# KING SOOPERS FUEL #84 AND CONDITIONAL USE

**COVER SHEET**

SITE PLAN

LANDSCAPE NOTES & DETAILS

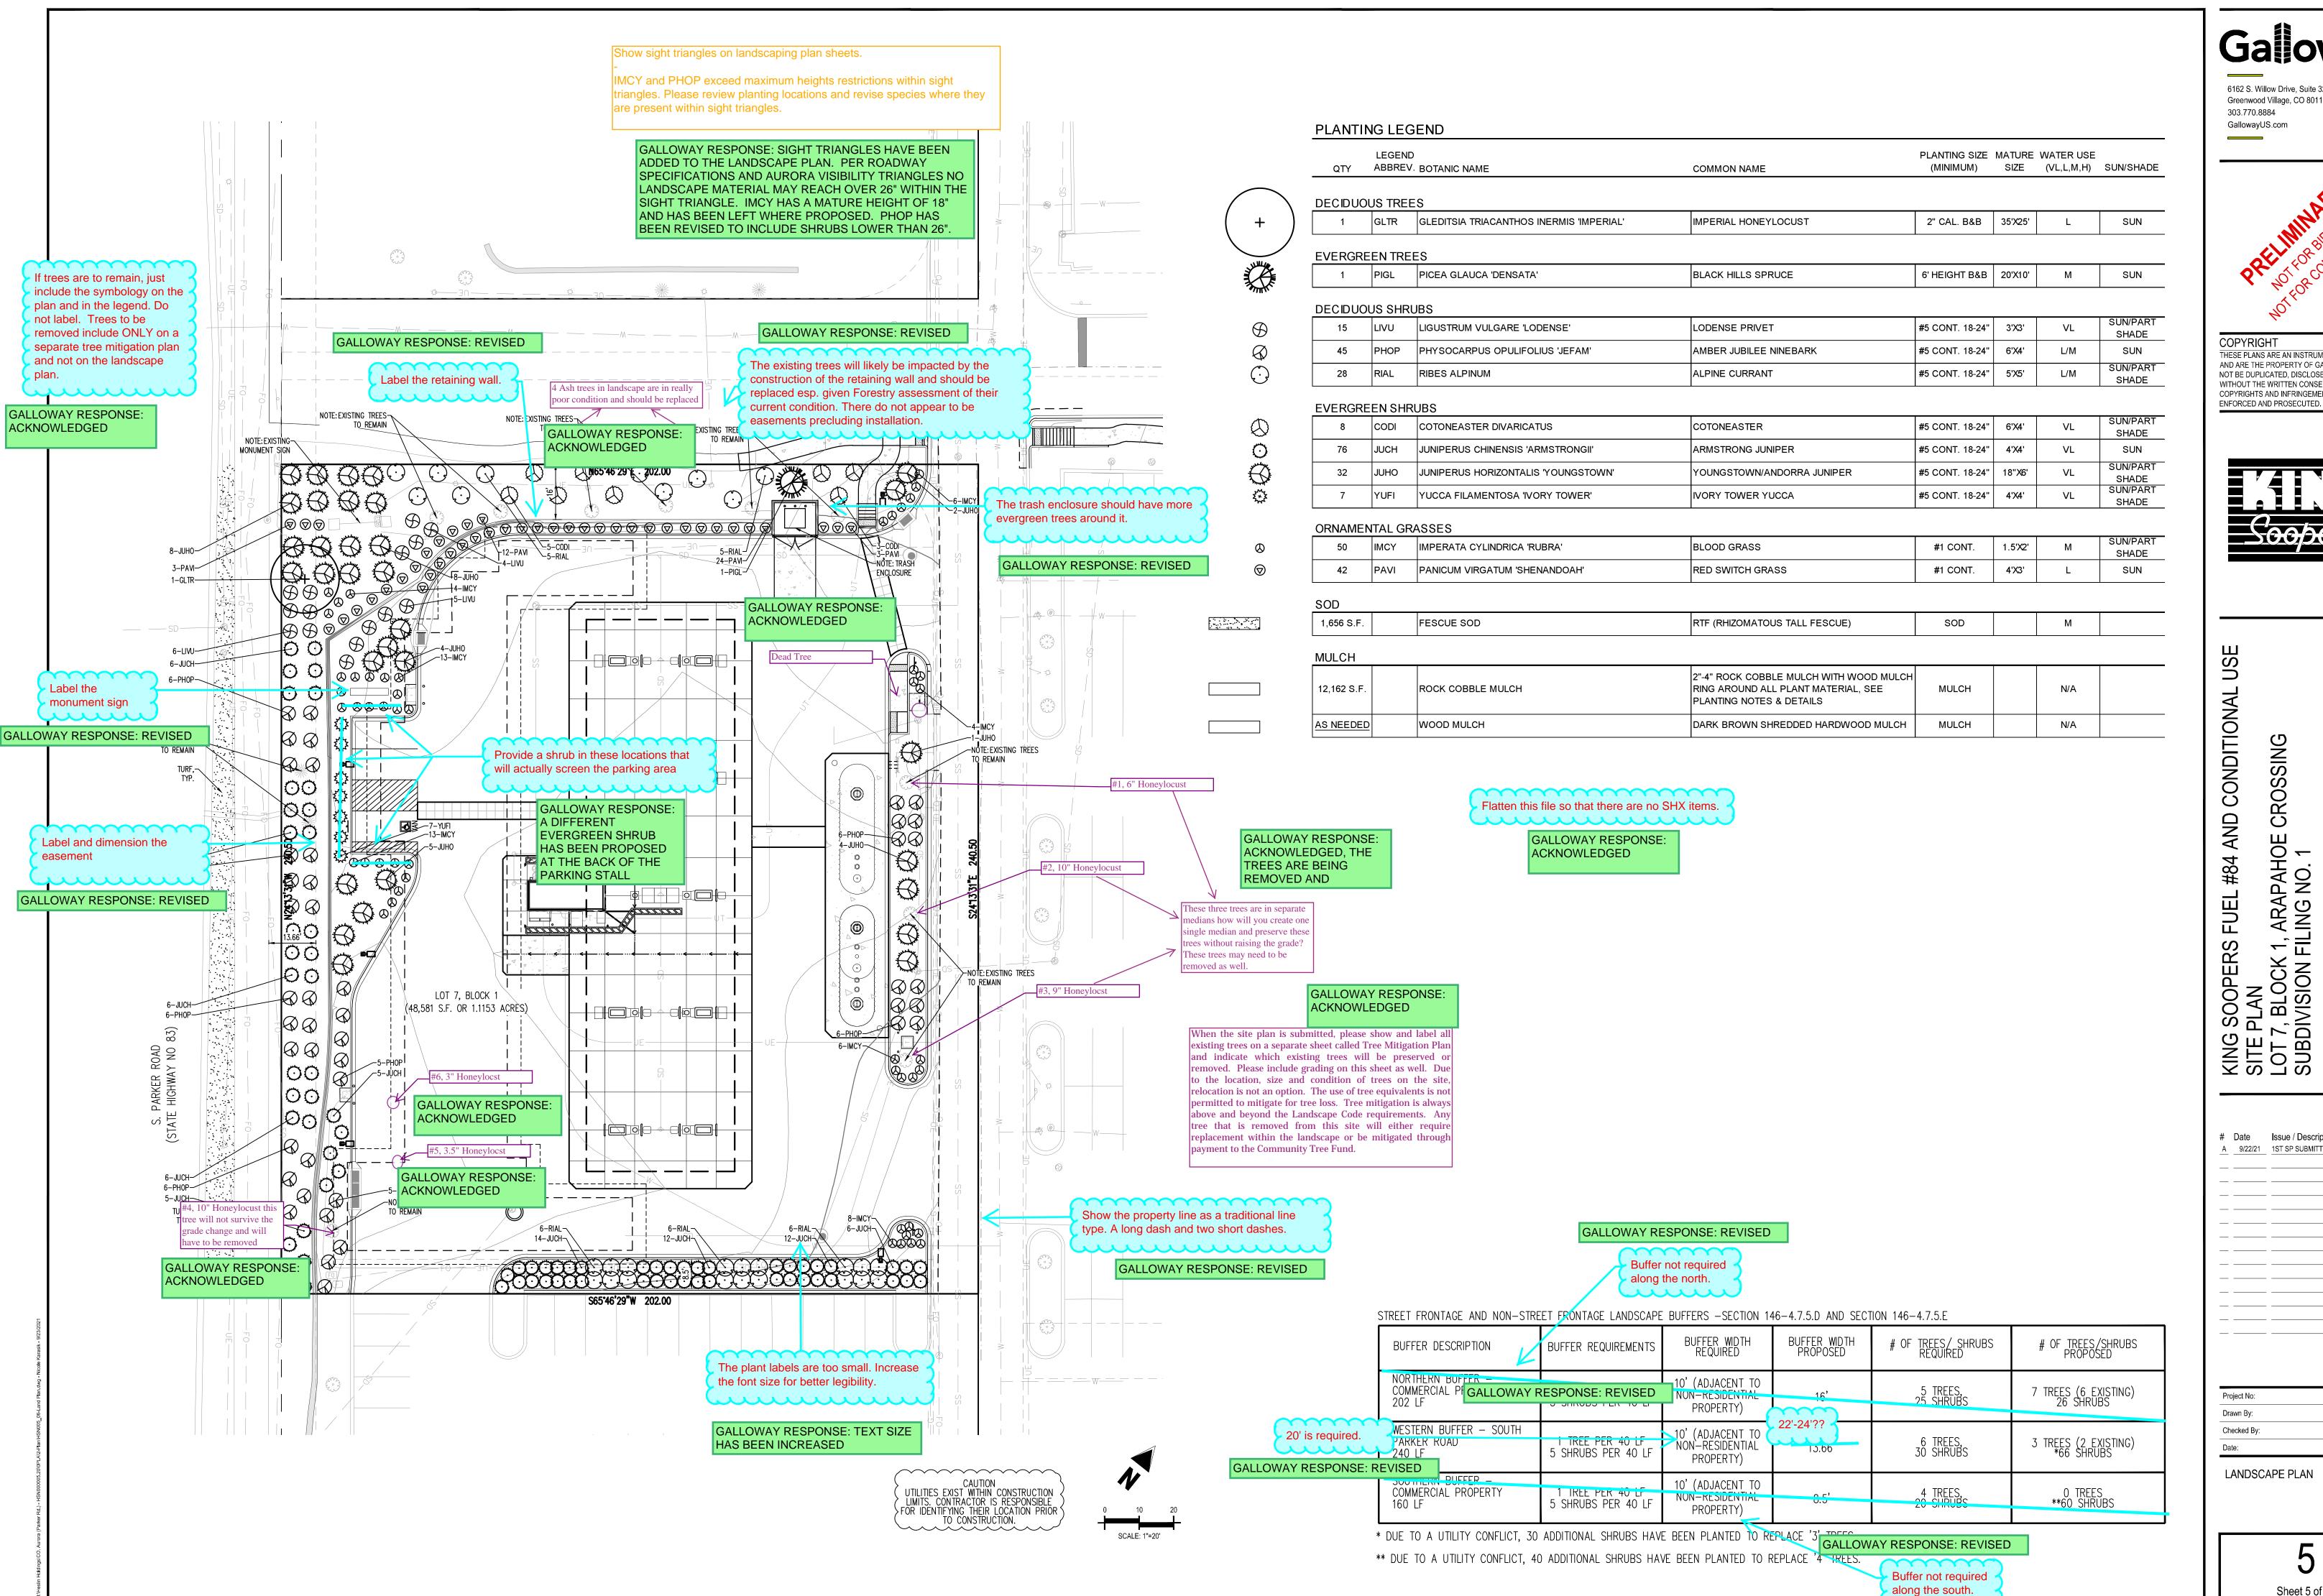
Sheet is out of order in the plan
